TECHNICAL INFORMATION

SUBJECT : Standard values for adjustment of focusing performance

MODEL : ① **GW/GSW690 Series Cameras** [Ref No. 1]
 ② **GS645 Series Cameras** [Ref No. 1]
 ③ **G/GX617 Camera** [Ref No. 1]

September 3, 1997

Table of Standard Values for Adjustment of Focusing Performance of Fuji Professional Cameras With Focus Adjust Stand (JF 010) Used

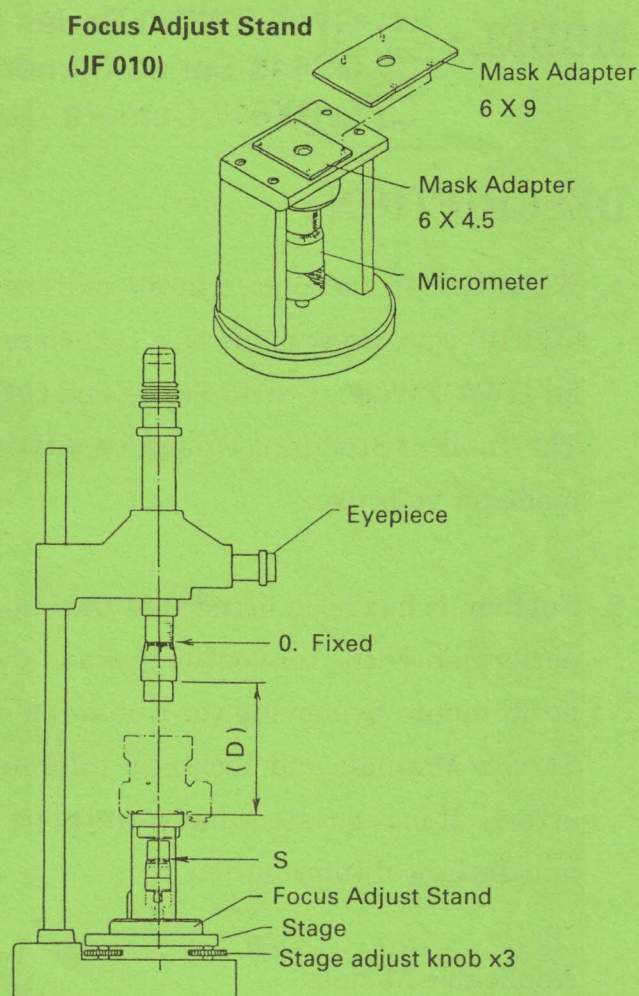
1. When GA645 was placed in the market for the first time, the focus adjust stand (JF010) was newly made as a GA645 repair tool, and this tool has also been used for GW/GSW690, GS645 Series and G/GX617 cameras which use large size films. The Table of Standard Values for Adjustment of Focusing Performance has been made for your use.
2. Further, it has been found that the standard values for adjustment of focusing performance (the conventional standard values used when checking focusing performance by moving the collimator objective lens) shown in the individual Service Manuals and Technical Information (No. PR-11-6, June 21, 1995) have errors. It is requested that corrections be made in the individual Service Manuals and Technical Information.

Models (f)	Micrometer adjust value (f)	
GW 690 Series (90mm)	15.15 ± 0.05	
GSW 690 Series (65mm)	15.15 ± 0.05	
GS 645J (70mm)	15.05 ± 0.1	
GS 645S (60mm)	15.00 ± 0.05	
GS 645W (45mm)	14.96 ± 0.05	
G 617 (105mm)	15.00 ± 0.02	
GX 617	(90mm)	14.95 ± 0.05
	(105mm)	14.95 ± 0.05
	(180mm)	14.95 ± 0.05
	(300mm)	14.95 ± 0.05

★Coincided with the film rail plane when the micrometer is set to 15.00mm

Table of Standard Values for Adjustment of Focusing Performance of Fuji Professional Cameras With Flat Mirror Used (Up-dated on September 1, 1997)

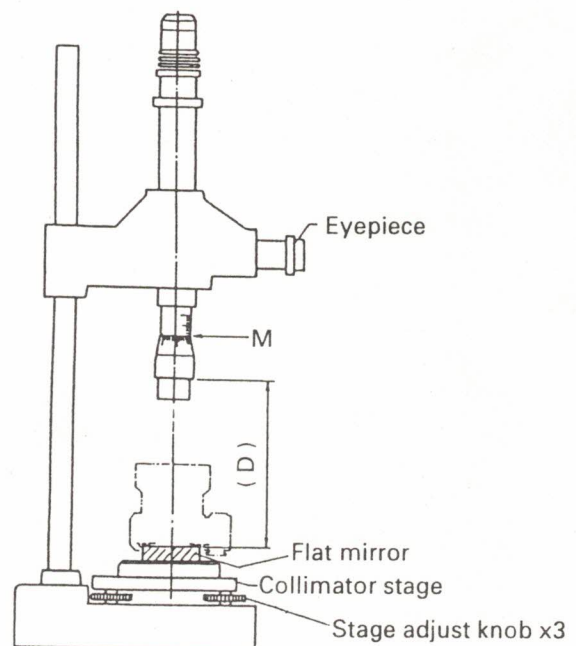
Note 2: When selecting a collimator for model of the camera to be adjusted, the following ratio will be the best:

[Collimator f = Camera f x2 or x3]

When this ratio is larger, an accuracy over will result, and it will become difficult to decide focus.

Collimator (f) Models (f)		Collimeter adjust value (M)			(D)
		24LT-2D(193.5)	32LT-2D(300)	T-500-0M(500)	
GW 690 Series	(90mm)	$+0.69 \pm 0.23$	$+1.66 \pm 0.56$	$+4.59 \pm 1.54$	200
GSW 690 Series	(65mm)	$+1.32 \pm 0.44$	$+3.17 \pm 1.06$	$+8.75 \pm 2.94$	200
GS 645J	(70mm)	$+0.38 \pm 0.76$	$+0.92 \pm 1.83$	$+2.54 \pm 5.06$	200
GS 645S	(60mm)	0 ± 0.52	0 ± 1.25	0 ± 3.45	200
GS 645W	(45mm)	-0.74 ± 0.92	-1.78 ± 2.22	-4.90 ± 6.12	200
G 617	(105mm)	★ 0 ± 0.10	0 ± 0.41	0 ± 1.14	200
GX 617	(90mm)	-0.23 ± 0.23	-0.56 ± 0.56	-1.54 ± 1.54	200
	(105mm)	★ -0.17 ± 0.17	-0.41 ± 0.40	-1.13 ± 1.13	200
	(180mm)	—	★ -0.14 ± 0.14	-0.39 ± 0.39	350
	(300mm)	—	—	★ -0.14 ± 0.14	350

SUBJECT : Changed encoder contact shape

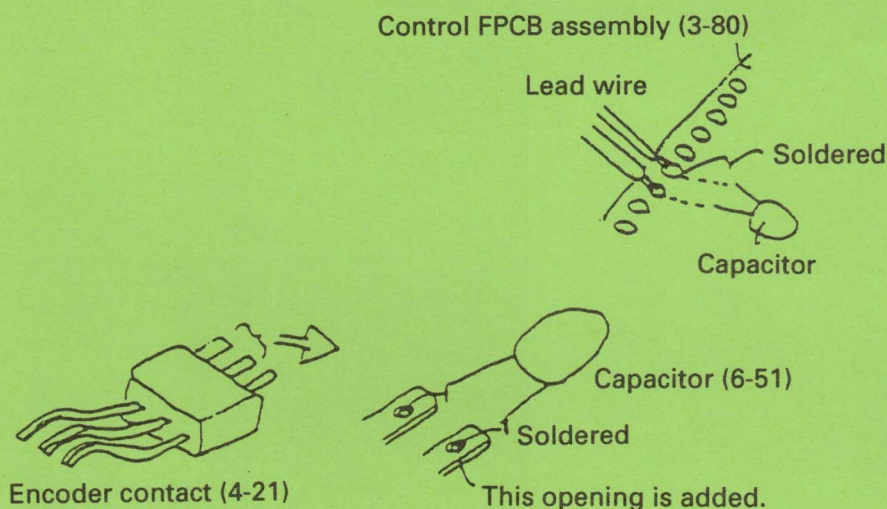
The capacitor attached to the control FPCB assembly (3-80) is soldered together with the lead wire. This is not ideal and the capacitor is now soldered to the encoder contact (4-21). To do so, the shape of the contact is changed.

This change is to improve reliability of the soldering.

Current			New			Inter-change-ability
Ref. No.	Part Name	Part No.	Ref. No.	Part Name	Part No.	
4 -21	Encoder contact	109B 7826860	4 -21	Encoder contact	109B 7826861	○
	Changed location		6 -51	Capacitor	116K 999680	○

SUBJECT : Changed TV value at flash firing under P mode

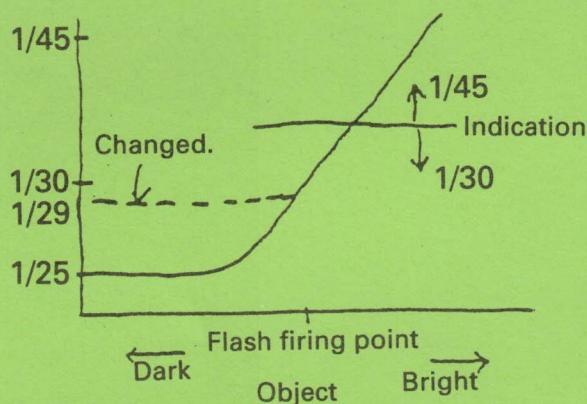
It has been reported that a hand shake (camera shake) occurs at flash firing under P mode when objects are dark.

TV value is increased from 1/25 to 1/29.

SUBJECT : Changed screw

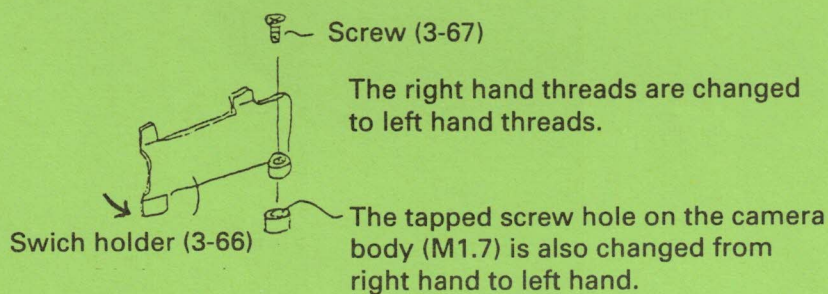
The screw (3-67) is changed from the right hand to left hand.

The switch holder (3-66) must be moved toward arrow.

This change is to ease the switch holder (3-66) installation.

Current			New			Inter-change-ability
Ref. No.	Part Name	Part No.	Ref. No.	Part Name	Part No.	
3- 67	Screw	110M170452M	3- 67	Screw	53B 7822660	×

SUBJECT: Changed gear ratio

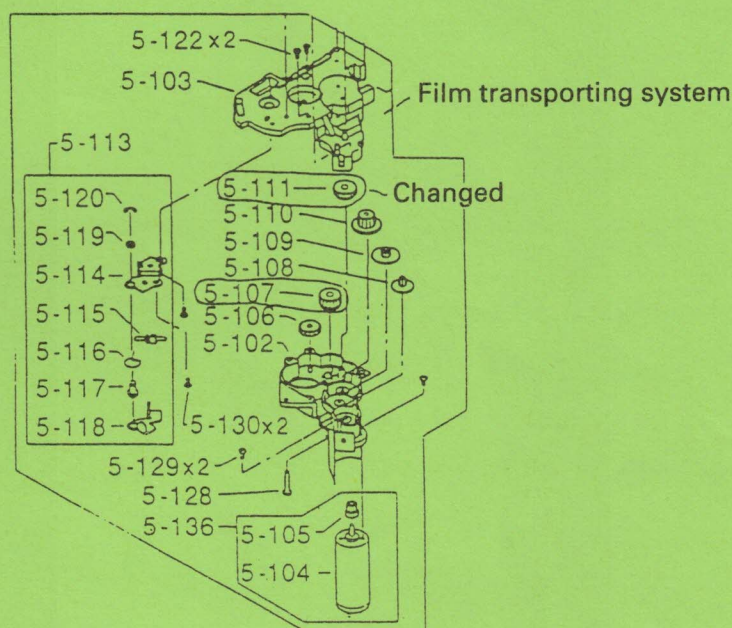
Torque is increased by changing gear ratio.

Replace the gear G5 (5-107) and gear G4 (5-111) as a set.

Number of gear teeth has been changed.

This change is to increase film taking up torque.

Current			New			Inter-change-ability
Ref. No.	Part Name	Part No.	Ref. No.	Part Name	Part No.	
5 -107	Gear G5	34B 6910111	5 -107	Gear G5	34B 7824260	×
5 -111	Gear G4	34B 6491400	5 -111	Gear G4	34B 7824250	×

SUBJECT : Changed battery compartment cover

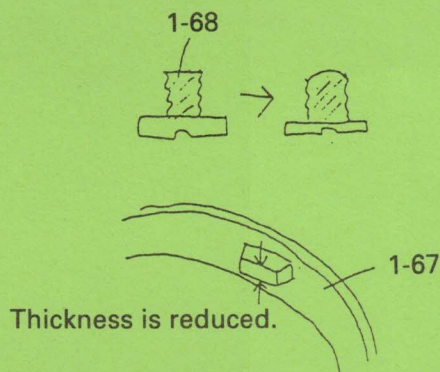
1. The set screw head is made to a spherical shape.
2. Thickness of the cover hook is reduced (to increase fitting play).

The battery compartment cover will be detached more easily.

Current			New			Inter-change-ability
Ref. No.	Part Name	Part No.	Ref No.	Part Name	Part No.	
1 -67	Battery compartment cover	11B 7822320	1 -67	Battery compartment cover	11B 7822321	○
1 -68	Set screw	53B 7822340	1 -68	Set screw	53B 7822342

SUBJECT : Improved shutter releasing with a cable release.

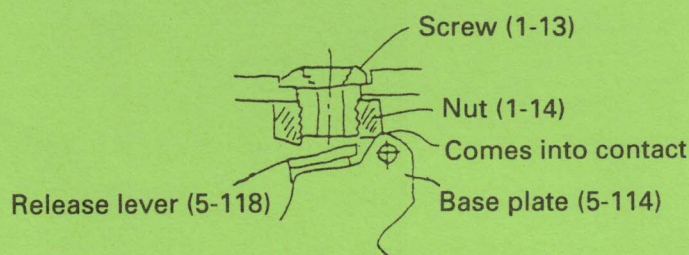
The nut for the shutter release set screw comes into contact with the base plate. This causes the release lever not to operate lightly and the switch dose not return from its ON position.

This change provides a space in between the nut and base plate.

Current			New			Inter-change-ability
Ref. No.	Part Name	Part No.	Ref No.	Part Name	Part No.	
1 - 14	Nut	54B 7824560	1 - 14	Nut	54B 7824563	○
5-114	Base plate	46B 7824040	5-114	Base plate	46B 7824041	○

SUBJECT : Prevention of overlapped pictures.

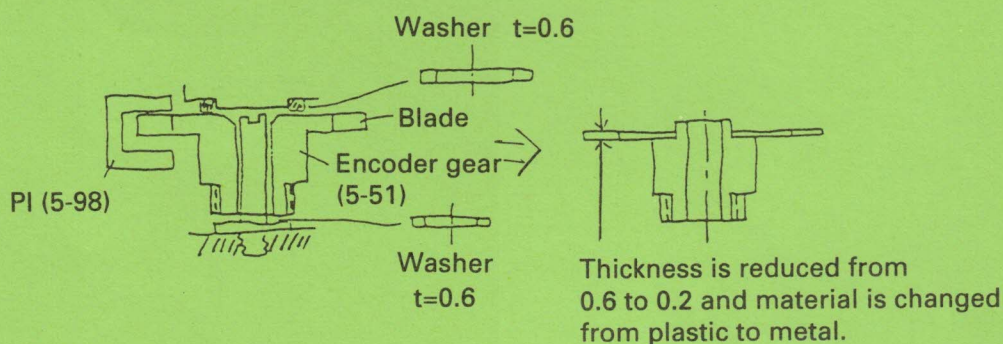
It was anticipated that the encoder gear blade might come into contact with the PI when the camera is faced downward because there was not enough space in between the blade and PI.

To provide more space in between the PI and encoder gear blade.

Current			New			Inter-change-ability
Ref. No.	Part Name	Part No.	Ref. No.	Part Name	Part No.	
5 -51	Encoder gear	34B 7823630	5 -51	Encoder gear	34A 7822880	○

SUBJECT : Countermeasure for film transporting noise

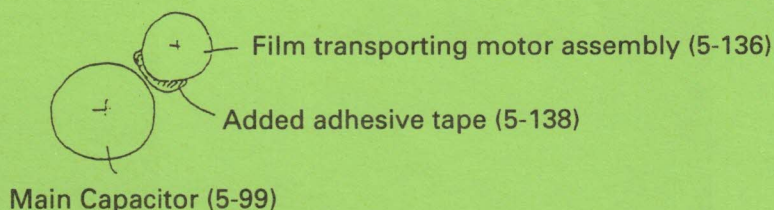
It has been reported that some cameras generate a film transporting (advancing) noise due to resonance with vibration of the film transporting motor. So the motor case is wound with a thick adhesive tape.

This change is to prevent motor vibration.

Current			New			Inter-change-ability
Ref. No.	Part Name	Part No.	Ref No.	Part Name	Part No.	
			5-138	Adhesive tape	187B7823690	○

SUBJECT: Replacement of gear train assembly (4-55)

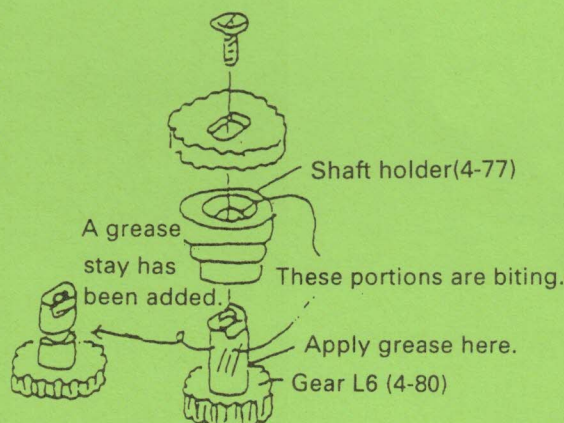
A trouble (The lens driving gear does not turn.) has been reported (Eight cases as of the end of November, 1995 out of 1,300 – Body Serial No. 505xxxx, 506xxxx).

When the lens is operating, the gear L6 (4-80) turns. But, this gear bites with the shaft holder (4-77) causing the lens operating slowly or not to operate. This trouble occurs due to an insufficient lubrication of the gear L6 (4-80). To solve this problem, the shaft of the gear L6 has been provided with a grease stay, effective June 22, 1995 (Body Serial No. 5070001) and thereafter.

When this trouble is anticipated, replace the gear train assembly (4-55) with a new one. Do not replace the gear L6 (4-80) alone. The shaft holder (4-77) may have been worn.

Former			New			Can be supplied or not
Ref. No.	Name	Part No.	Ref. No.	Name	Part No.	
4-55	Gear train assembly	46A 7827310	4-55	Gear train assembly	46A 7827311	○

SUBJECT : Improved first frame set time

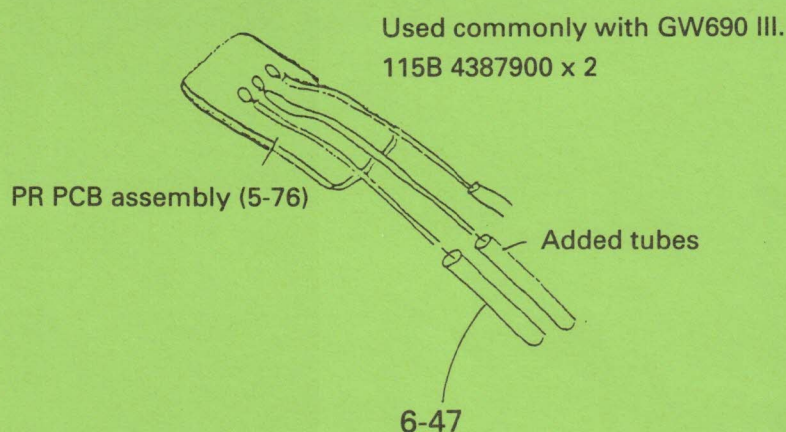
It was anticipated that the lead wires might be bit by the soldered portion of the PR PCB assembly (5-76) causing a short-circuit. So, tubes are applied to the lead wires to protect them from damaging.

The tubes are added to prevent short-circuit.

Current			New			Inter-change-ability
Ref. No.	Part Name	Part No.	Ref No.	Part Name	Part No.	
		None	6-47	Tube	115B4387900	○

SUBJECT: Additional information for new/former type FPCB part numbers and identifying method

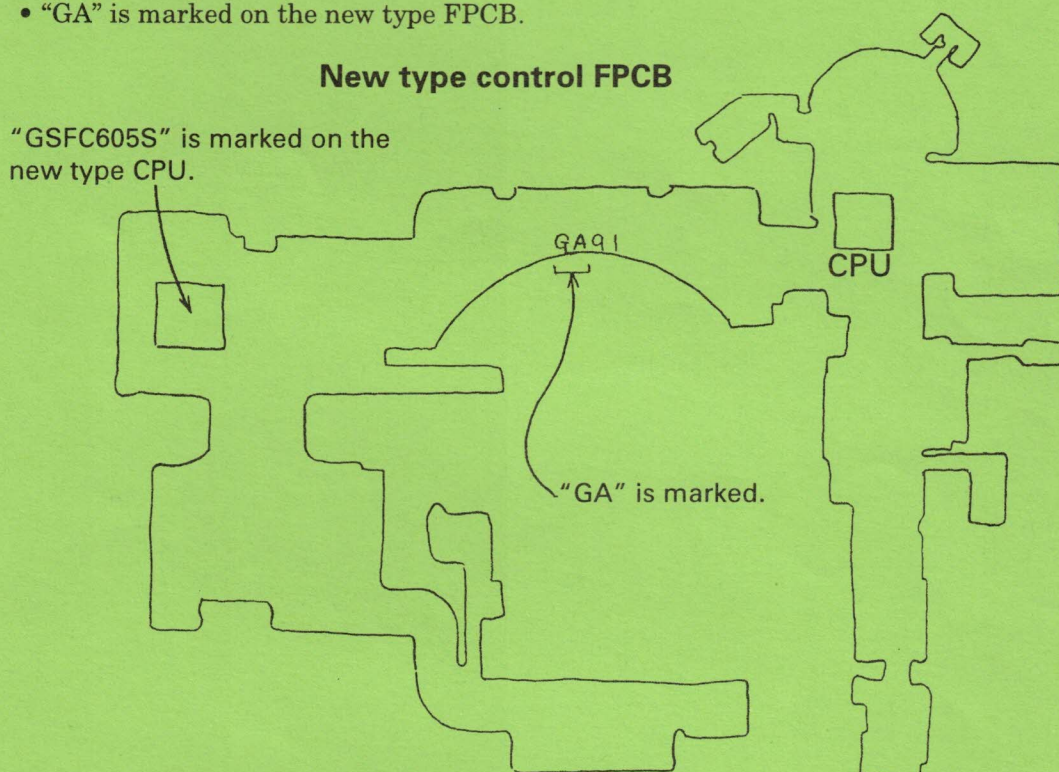
(1) Identifications of new type CPU and new type FPCB

- "GSFC605S" is marked on the new type CPU. (Already informed by Technical Information No. 96-53)
- "GA" is marked on the new type FPCB.

Current			New			Can be supplied or not
Ref. No.	Part Name	Part No.	Ref No.	Part Name	Part NO.	
3-70	Control FPCB assembly	110A 7821810	3-70	Control FPCB assembly	110A 8520930	○
